## **Oil Leakage from Front Chaincase**

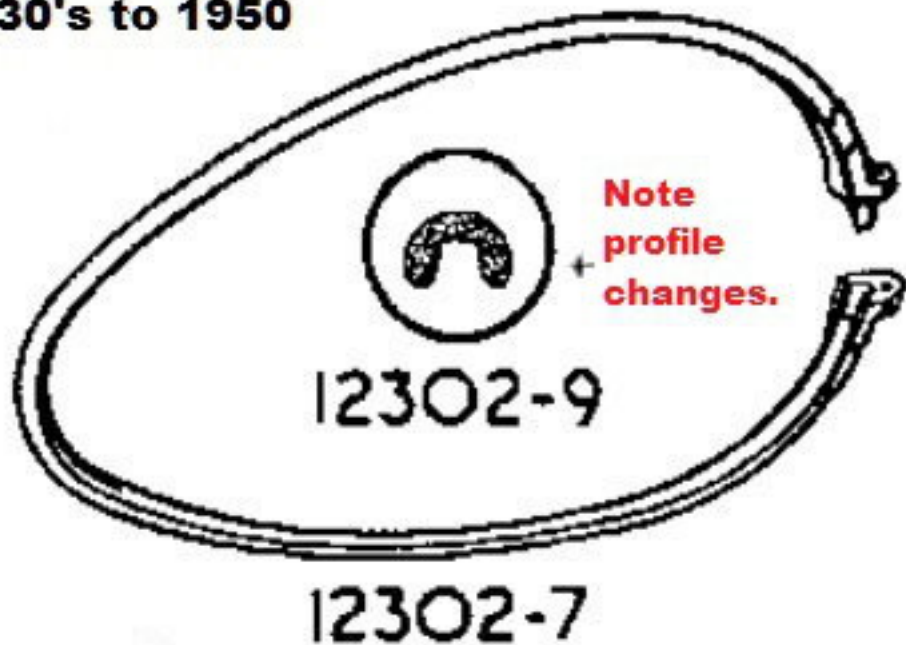
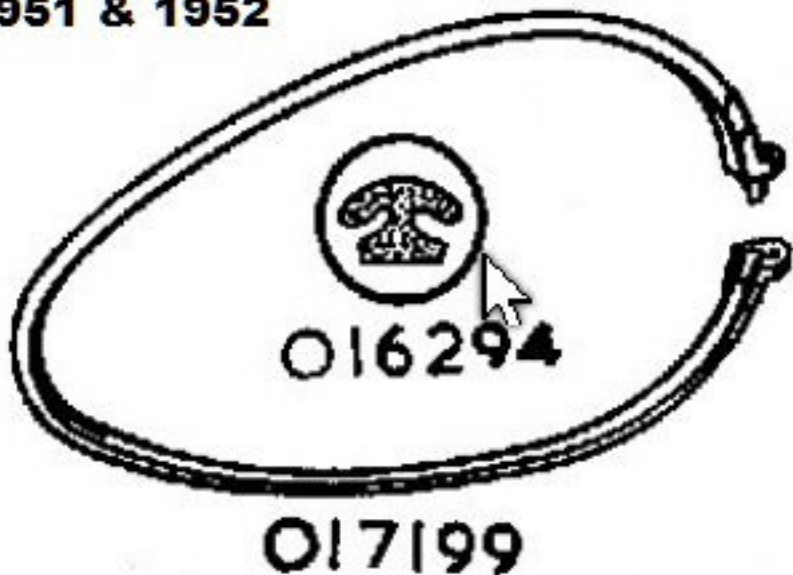
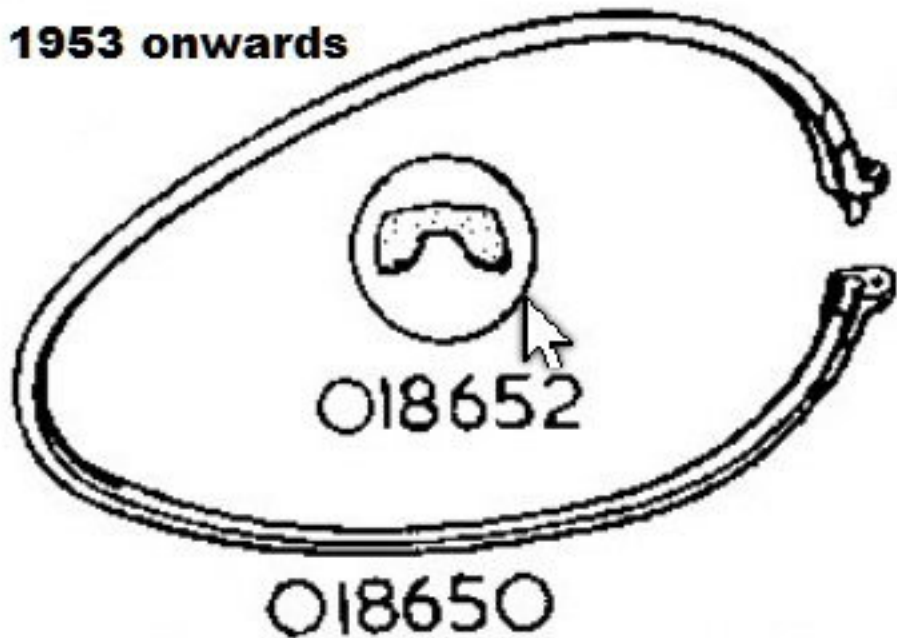
A new type of rubber chaincase-band is now available which is mushroom in section, with a narrow and a wide groove for both the front and rear portions of the chaincase. Where persistent oil leaks occur from this part of the machine, the new type rubber case will provide the remedy.
